APPLICATION NO.	FILING DATE	FIRST NAMED INVENTOR	ATTORNEY DOCKET NO.	CONFIRMATION NO.
10/051,486	01/18/2002	John D. Phillips	24457B	1435
22889	7590 11/05/2003		EXAMINER	
OWENS CORNING			TRAN A, PHI DIEU N	
2790 COLUMBUS ROAD GRANVILLE, OH 43023			ART UNIT	PAPER NUMBER
Old II V IEEE	, 011 13023		3637	,

Application No.	Applicant(s)				
Office Action Comment	10/051,486	PHILLIPS, JOHN D.				
Office Action Summary	Examiner	Art Unit				
TI MAN NO DATE (11)	Phi D A	3637				
The MAILING DATE of this communication appears on the cover sheet with the correspondence address Period for Reply						
A SHORTENED STATUTORY PERIOD FOR REPLY IS SET TO EXPIRE 3 MONTH(S) FROM THE MAILING DATE OF THIS COMMUNICATION. - Extensions of time may be available under the provisions of 37 CFR 1.136(a). In no event, however, may a reply be timely filed after SIX (6) MONTHS from the mailing date of this communication. - If the period for reply specified above is less than thirty (30) days, a reply within the statutory minimum of thirty (30) days will be considered timely. - If NO period for reply is specified above, the maximum statutory period will apply and will expire SIX (6) MONTHS from the mailing date of t

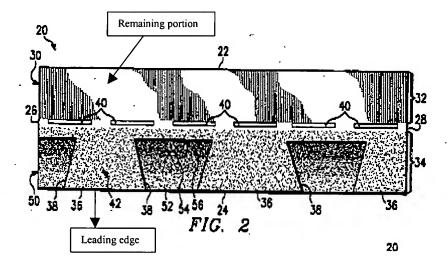
Weaver et al (below) shows a laminated roofing shingle having an overlay(20) having an underside and a plurality of spaced apart tabs (36), each one of the tabs (36) having a leading edge (see below), a first shadow line (42 extending to area of 26 and 28) and a remaining portion (the portion above the first shadow line and below the portions 32 or 30), the tabs defining openings adjacent the tabs, a layer of granules disposed on the first shadow line of the tabs and on the remaining portion of the tabs, the granules on the first shadow line of the tabs being substantially darker in color than the granules on the remaining portion of the tabs, an underlay (50) attached to the underside of the overlay to cooperatively form the laminated roofing shingle, the underlay having a leading edge (52), a second shadow line (56), a remaining portion between the leading edge of the underlay and the second shadow line, the leading edge of the underlay generally co-aligning with the leading edge of the tabs, the underlay having a portion exposed through the openings defined adjacent the tabs, a layer of granules disposed on the underlay, the granules on the second shadow line of the underlay being substantially darker than the granules on the remaining portion of the underlay, said overlay and said underlay are each formed from a

base material comprising fiberglass mat that has been coated with asphalt, the granules on the first shadow line and the granules on the second shadow line being black granules (col 4 line 5).

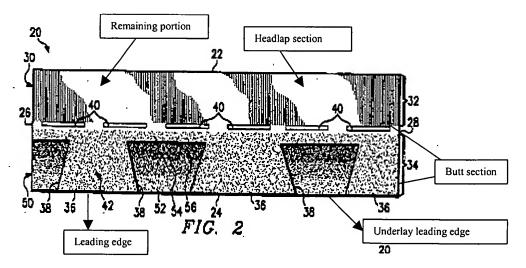
Weaver et al (below) shows a laminated roofing shingle comprising an overlay having an underside, headlap section (sections comprise of 30 or 32), a plurality of spaced apart tabs (36) extending from the headlap section, the headlap section having a leading edge (the leading edge of 30 or 32), each one of the tabs having a leading edge (36), an outer surface, a first shadow line (42) and a remaining portion (the portion between 34 and 32), said firs shadow line and the remaining portion being on the outer surface of the tabs, the first shadow line extending from the leading edge of the tabs to the remaining portion of the tabs, the tabs and the leading edge of the headlap section defining openings, a layer of granules disposed on the first shadow line of the tabs and on the remaining portion of the tabs, the granules on the first shadow line (42) of the tabs being substantially darker in color than the granules on the remaining portion of the tabs, an underlay (50) attached to an underside of the overlay to cooperatively form the laminated roofing

shingle, the underlay having an outer surface, a leading edge, a trailing edge, a second shadow line (56) and a remaining portion (54) between the leading edge of the underlay and the second shadow line, the leading edge of the underlay generally co-aligning with the leading edge of the tabs, the second shadow line and the remaining portion of the underlay being on the outer surface of the underlay, the second shadow line extending from the trailing edge of the underlay to the remaining portion of the underlay, the underlay having a portion exposed through the openings defined by the tabs and the leading edge of the headlap section, the second shadow line being exposed through the opening and adjacent the leading edge of the headlap section, a layer of granules disposed on the underlay, the granules on the second shadow line (56) being substantially darker than the granules on the remaining portion of the underlay, the overlay and the underlay each being formed form a base material comprising a fiberglass mat that has been coated with asphalt, the granules on the first shadow line and the granules on the second shadow line being black.

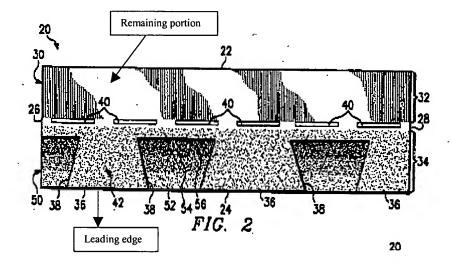
Weaver et al (below) shows a laminated roofing shingle having an overlay having a tab (36) with a leading edge having granules thereon and a remaining portion having granules thereon, the leading edge granules being darker than the remaining portion granules, an underlay (50) attached to the overlay, the underlay having a shadow line (56) having granules thereon and a remaining portion having granules thereon, the shadow line granules being darker than the underlay remaining portion granules.

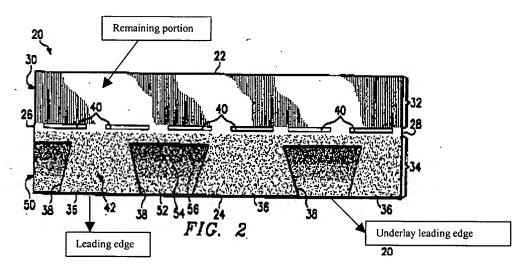
Weaver et al (below) shows a laminated roofing shingle having an overlay having a tab (36) with a leading edge, a first shadow line (42), and a remaining portion, the shadow line being positioned between the leading edge (see below) and the remaining portion (see below), a layer of granules disposed on the first shadow line and on the remaining portion of the tab (the portion located at around 26, 28), the granules on the first shadow line being darker in color than the granules on the remaining portion, an underlay attached to the underside of the overlay to cooperatively form the laminated roofing shingle, the underlay having a leading edge, a second

shadow line (56) and a remaining portion between the leading edge of the underlay and the second shadow line, the leading edge of the underlay generally co-aligning with the said leading edge of the tab, the underlay having an exposed portion, a layer of granules disposed on the underlay, the granules on the second shadow line (56) of the underlay being generally darker than the granules on the remaining portion of the underlay.

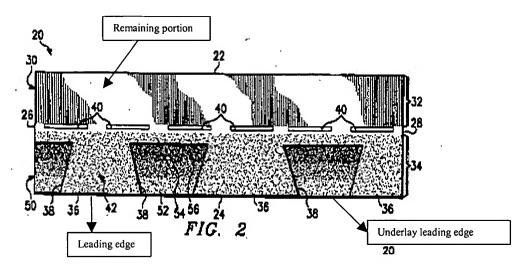
Weaver et al (below) shows a laminated roofing shingle having an overlay having a tab (36) with a leading edge, a first shadow line (42), and a remaining portion, the shadow line being positioned between the leading edge (see below) and the remaining portion (see below), a layer of granules disposed on the first shadow line and on the remaining portion of the tab (the portion located at around 26, 28), the granules on the first shadow line being different color or shade than the granules on the remaining portion, an underlay attached to the underside of the overlay to cooperatively form the laminated roofing shingle, the underlay having a leading edge, a second shadow line (56) and a remaining portion between the leading edge of the underlay and

the second shadow line, the leading edge of the underlay generally co-aligning with the said leading edge of the tab, the underlay having an exposed portion, a layer of granules disposed on the underlay, the granules on the second shadow line (56) of the underlay being a different color or shade than the granules on the remaining portion of the underlay.

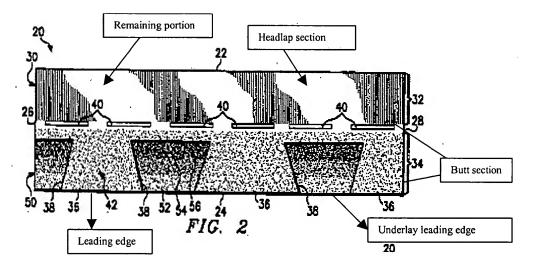
Weaver et al (below) shows a laminated roofing shingle having a headlap section and a butt section (the section starting below 30 or 32) comprising an overlay having a tab (36), the tab having an outer surface with a trailing edge adjacent the headlap section and a leading edge (36) spaced from the trailing edge, the tab having a width, an underlay (50) attached to an underside of the overlay, the underlay having an outer surface, the underlay outer surface positioned adjacent the tab with a trailing edge (26) adjacent the headlap section, a leading edge spaced from the trailing edge and first colored granules (42) adhered to the outer surface of the tab adjacent the leading edge of the tab, second colored granules (the part around the openings 40) adhered to the outer surface of the tab separated from the leading edge (36) of the tab by the

first colored granules, the second colored granules having a different coloration or shade than the first colored granules, third colored granules (56) adhered to the trailing edge of the outer surface of the underlay, fourth color granules (52) adhered adjacent the leading edge of the outer surface of the underlay having different coloration or shade than the third colored granules, said first colored granules form a shadow line adjacent the leading edge of the tab across substantially the entire width of the tab, the first colored granules (42)comprise darker granules than the second colored granules, the first colored granules comprise black colored granules, the third colored

granules (56) form a shadow line adjacent the trailing edge of the outer surface of the underlay, the third colored granules comprise darker granules than the fourth colored granules, the first and third colored granules comprise black colored granules, a second tab (the next tab), the second tab adjacent the outer surface of the underlay, the second tab having sixth colored granules (42) forming a shadow line adjacent a leading edge of the second tab.
